REGIONAL REVIEW FINDING

ARC REVIEW CODE: R1712011

Name of Proposal: The Heights at Woodstock (DRI 2741)

DRI SITE PLAN (DRI #2741)
THE HEIGHTS AT WOODSTOCK
LAND LOTS 1231 & 1232 - 15th DISTRICT
CHEROKEE COUNTY, GEORGIA

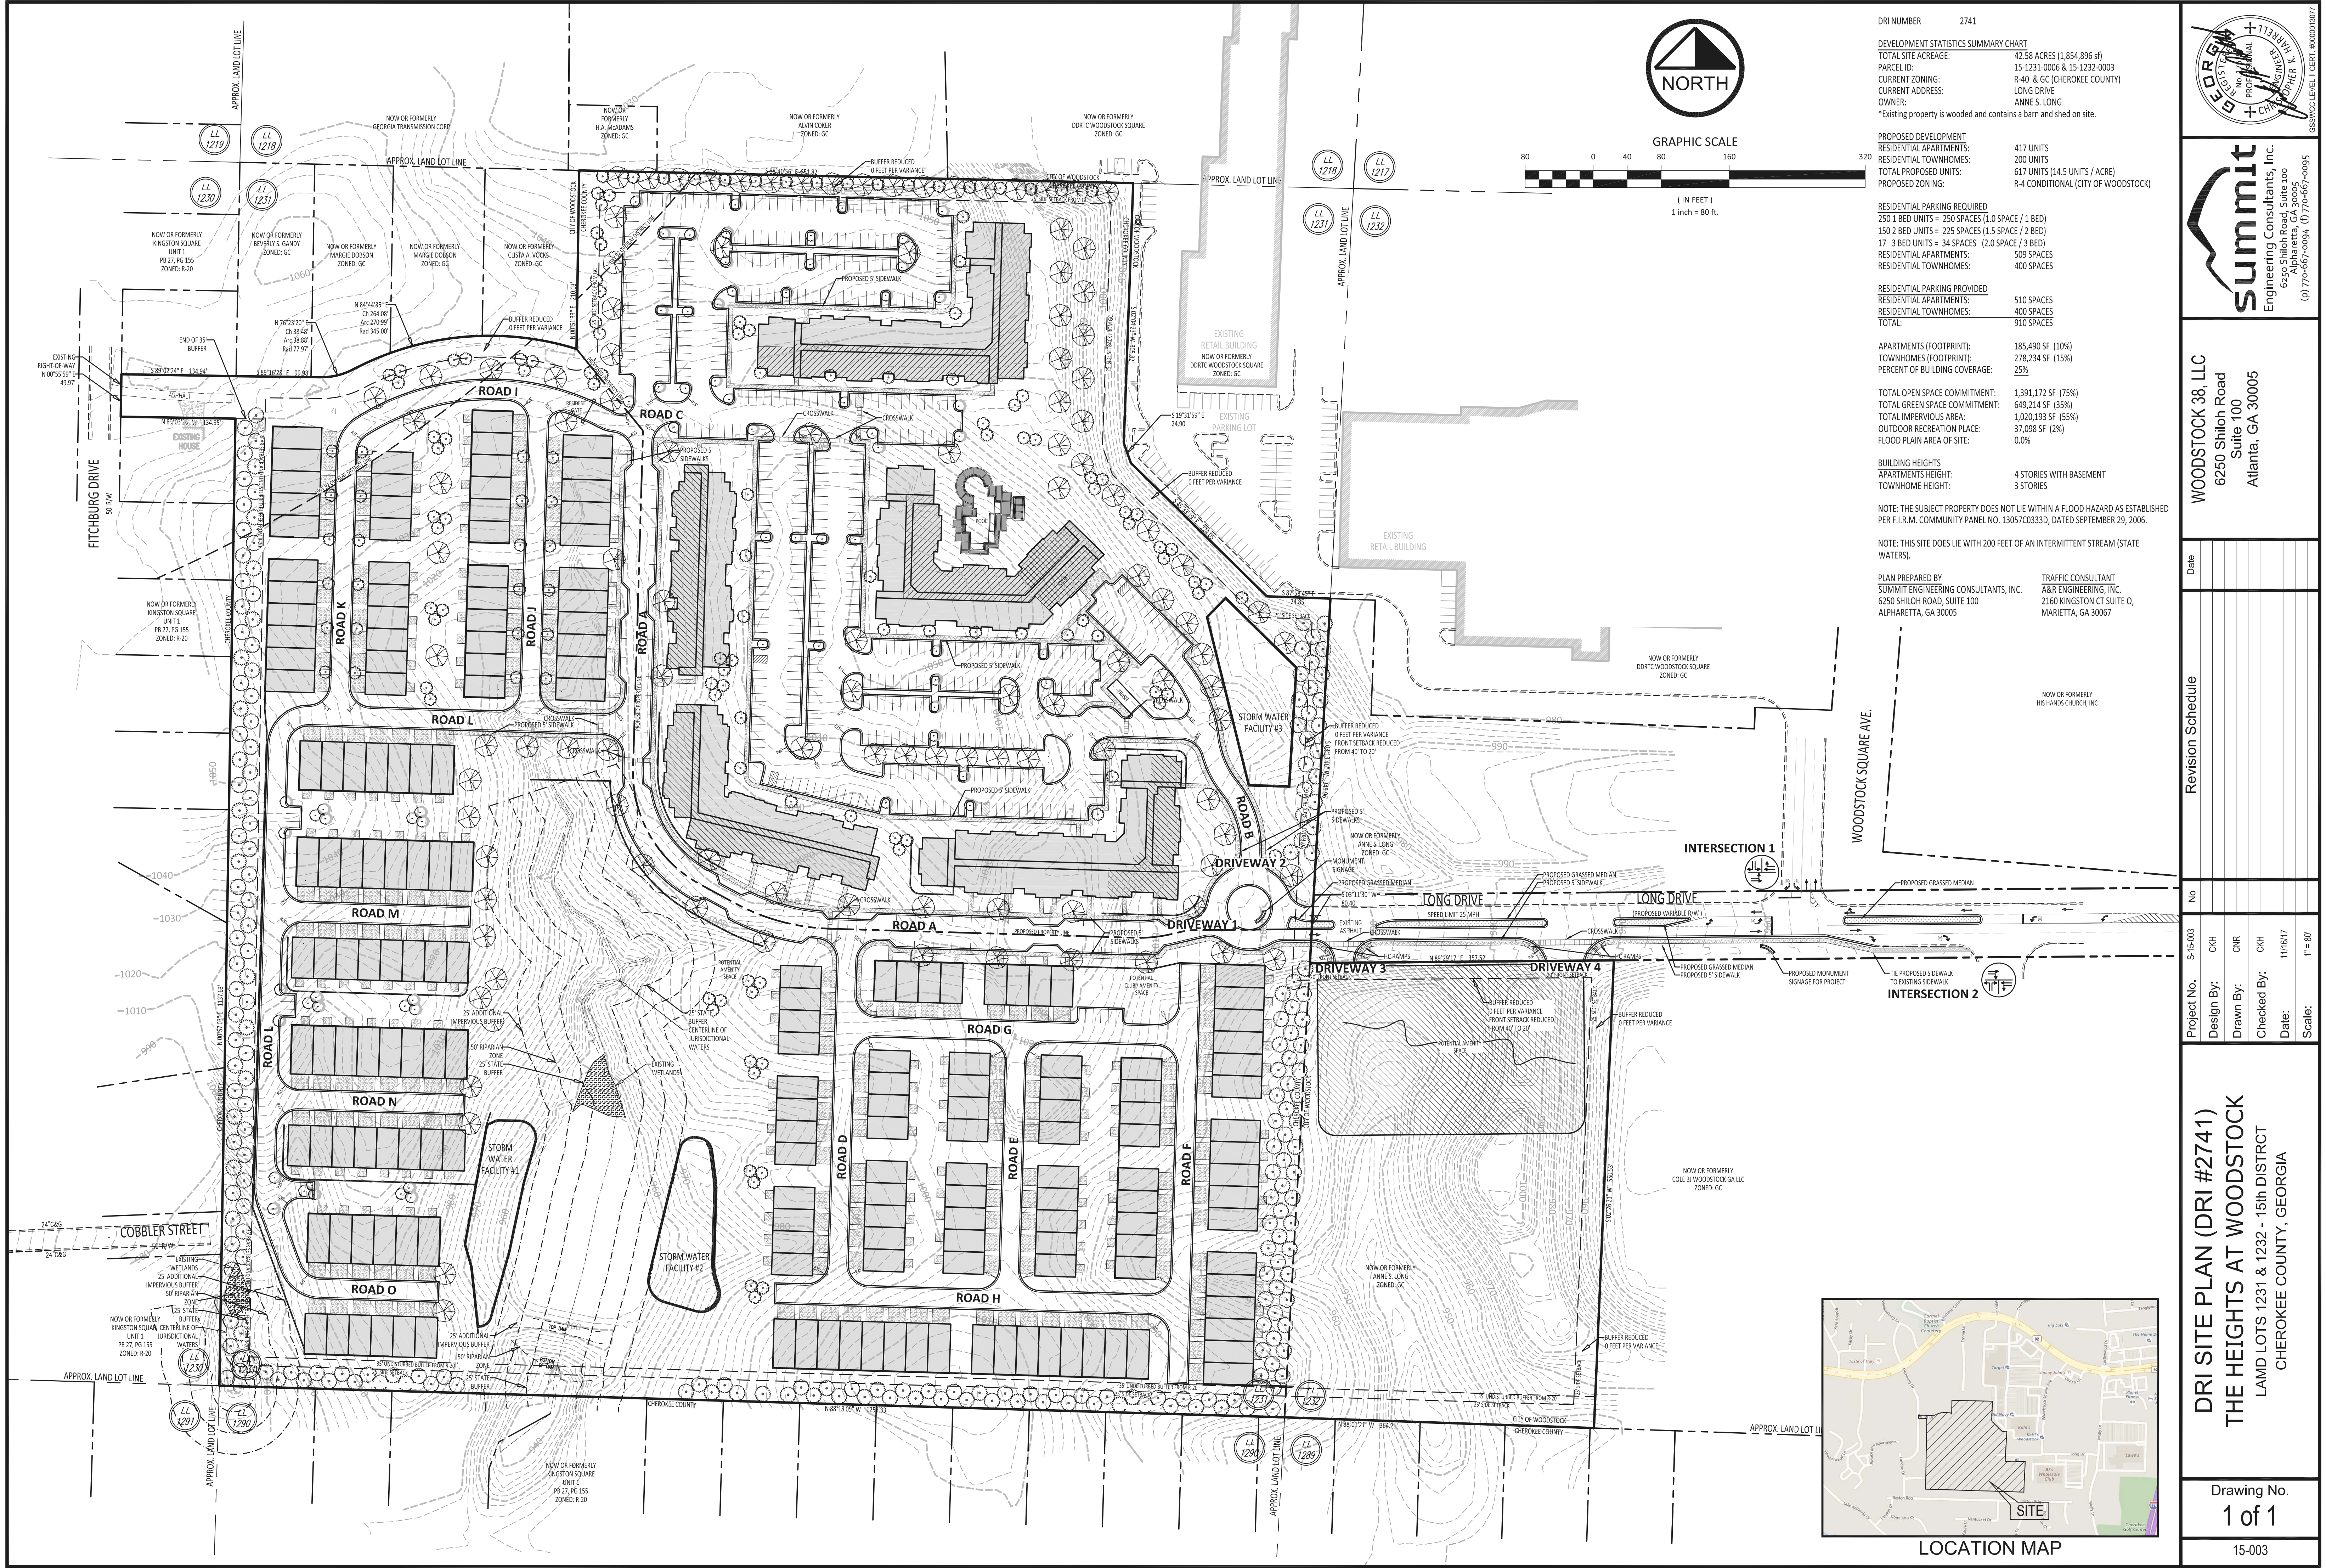
The proposed development is accessed from Long Drive, a local Road and site circulation via internal driveways. Existing single family residential uses are adjacent to the site on the western and southern boundaries making vehicular connectivity impractical. Commercial uses abut the northern property boundary line. No vehicular connection is proposed to adjacent commercial uses.

The development proposes a landscape buffer between neighboring uses and does not provide pedestrian facility connections to adjacent commercial uses, however, there are no proposed restrictions to pedestrians accessing adjacent parcels.

Pedestrian facilities such as designated walking paths or sidewalks should be considered to provide pedestrian access to neighboring commercial uses.
